SSDA Accessibility Report

195-213 Fitzgerald Avenue & 40-64 Yorktown Parade, Maroubra NSW 2035

Prepared for: Homes NSW
Our Ref: 24000409 | Issue date: 18 October 2024

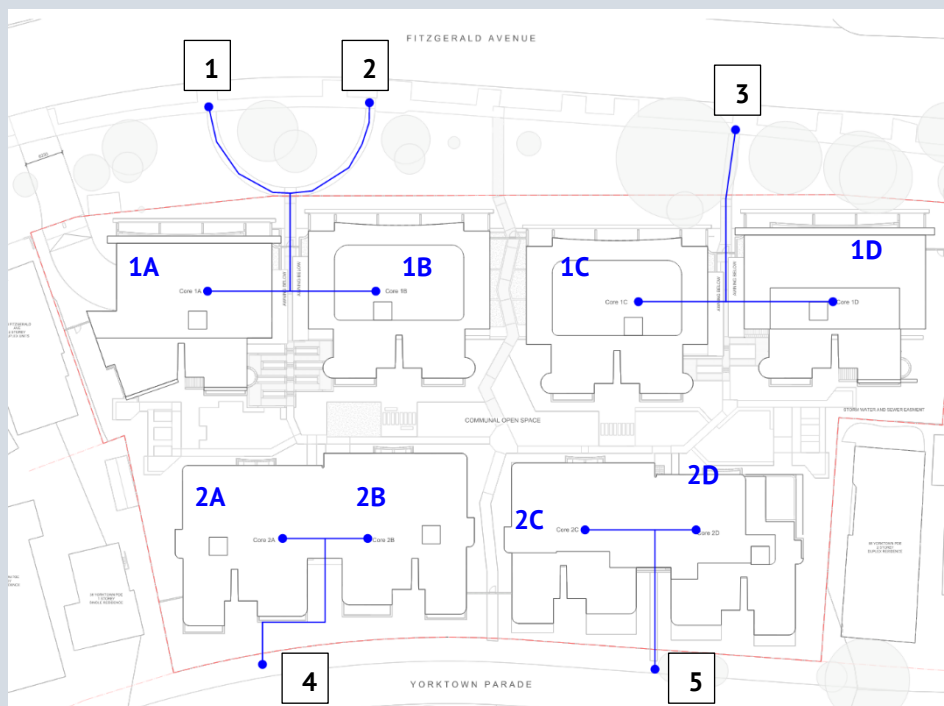
- (Ground Floor level) - A total of five (5) access points are provided from the site boundary to the six (6) buildings:

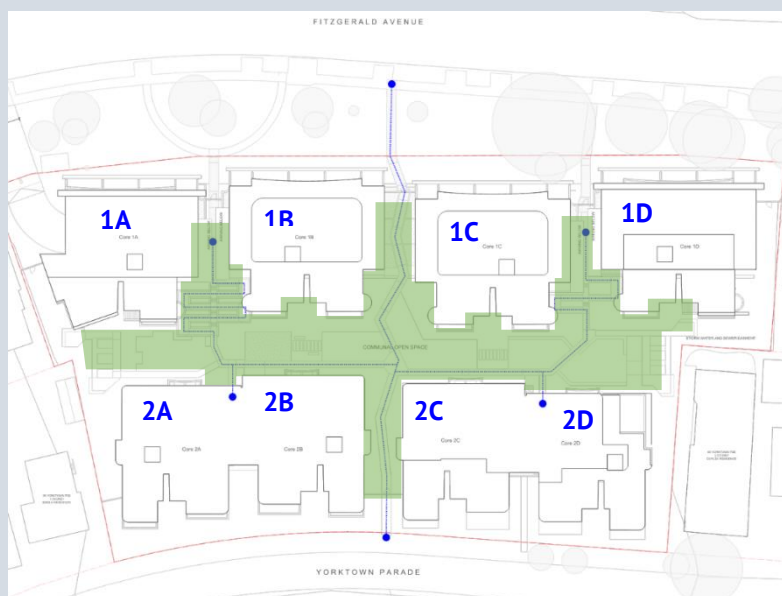
- Three (3) entrances are provided along Fitzgerald Avenue, on-grade/level access is provided via footpath leading to 1A and 1B. Buildings 1C and 1D provide a walkway link from the allotment boundary in accordance with AS1428.1.
- Both entrances facing Fitzgerald Avenue provide gates that lack suitable circulation clearance, these are to be provided in accordance with AS1428.1 or gates are to be power operated.
- (Lower Ground Floor) -There are two (2) entrances via Yorktown Parade, for buildings 2A and 2B access is via walkway and a 1:14 ramp these are to ensure compliance with AS1428.1. This includes suitable clear circulation spaces to achieve 90degrees turns in accordance with AS1428.1.

For building 2C and 2D access is provided via on-grade/level access is provided via footpath.

- The secondary entrance to the development divides the site with a series of zigzag walkways extending from the allotment boundary to the communal space.
- The proposed security gates along the continuous accessible path of travel do not provide adequate latch side clearance.
- To address this, either provide sufficient latch side clearance for the gates or ensure they are power operated.
- The front approach clearance must comply with AS1428.1, Figure 31.
